NUMBER: 03-001-15 REV. A

GROUP: Differential &
Driveline

THIS BULLETIN SUPERSEDES SERVICE BULLETIN 03-001-15, DATED May 30, 2015, WHICH SHOULD BE REMOVED FROM YOUR FILES. ALL REVISIONS ARE HIGHLIGHTED WITH **ASTERISKS**** AND INCLUDE REVISED SYMPTOM/CONDITION, ADDING AN ADDITIONAL AXLE SHAFT PART NUMBER TO THE PARTS REQUIRED SECTION, AND DATE CODE INSPECTION STEPS.**

Rear Half Shaft Vibration

Fig. 1 Identification Label Location

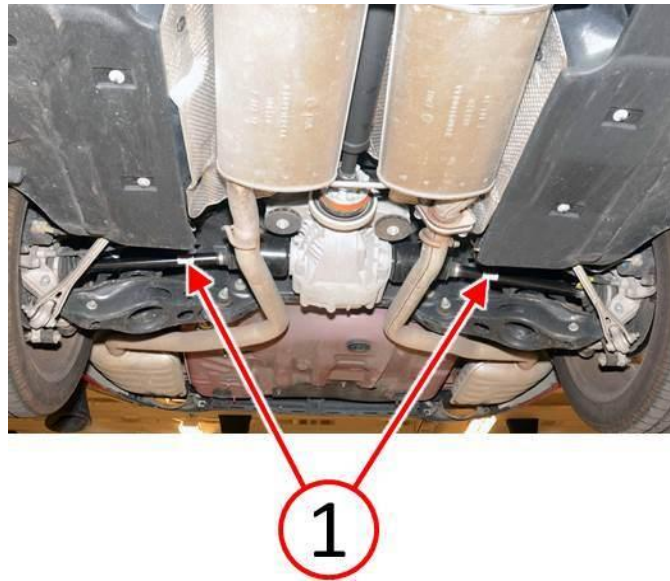
1. **Raise the vehicle and locate the axle shaft identification labels (1) (Fig. 1). Refer to the detailed service procedures available in DealerCONNECT> TechCONNECT under: Service Info> 04 - Vehicle Quick Reference> Hoisting> Standard Procedure.**

Fig. 2 Identification Label Information

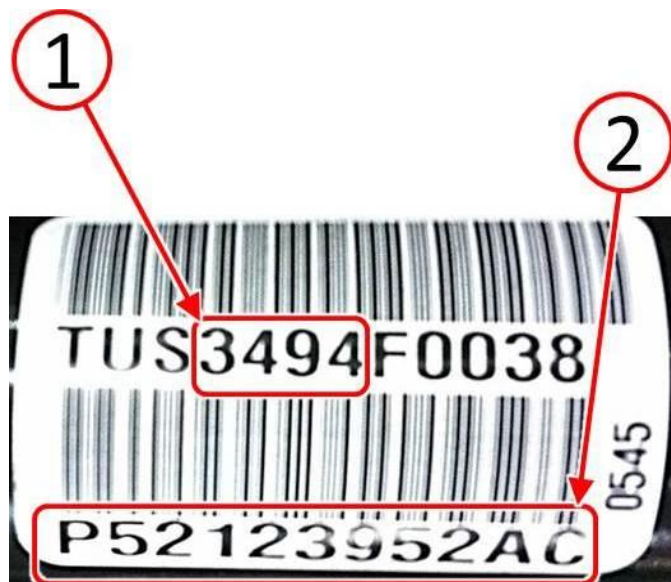
2. ****Inspect the affected date code range (1) on both axle shaft identification labels (Fig. 2).****

3. ****Is the affected date code range any number between 3094 through 3384?**

- a. YES>>> Continue with the Repair Procedure [Step #4](#).
 - b. NO>>> This bulletin has been completed, use LOP (03-20-03-92) to close the active RRT. If the customer described the symptom/condition listed above, normal diagnosis should be performed.**
4. Replace both rear half shafts. Refer to the detailed service procedures available in DealerCONNECT> TechCONNECT under: Service Info> 02 - Differential and Driveline> Half Shaft> Removal/Installation.
